TC-90 RMT CONNECTOR OPTION WIRING

TC-90 RMT OPTION

ENCODER Board Change

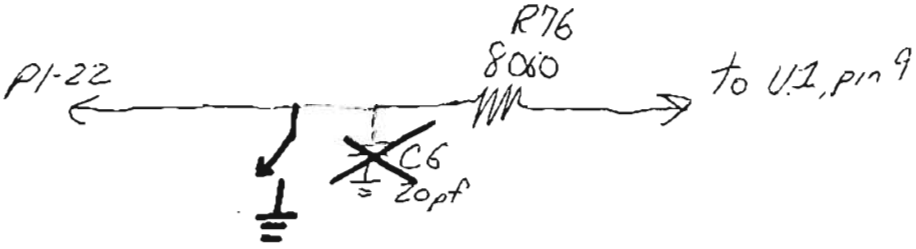
Encoder VITC switch not installed on two cameras down there

Remove C6 and install switch provided:

Switch is installed between feedthru and gnd hole vacated by C6. If you don't understand, check the camera we sent down.

Switch should be in "1" position.
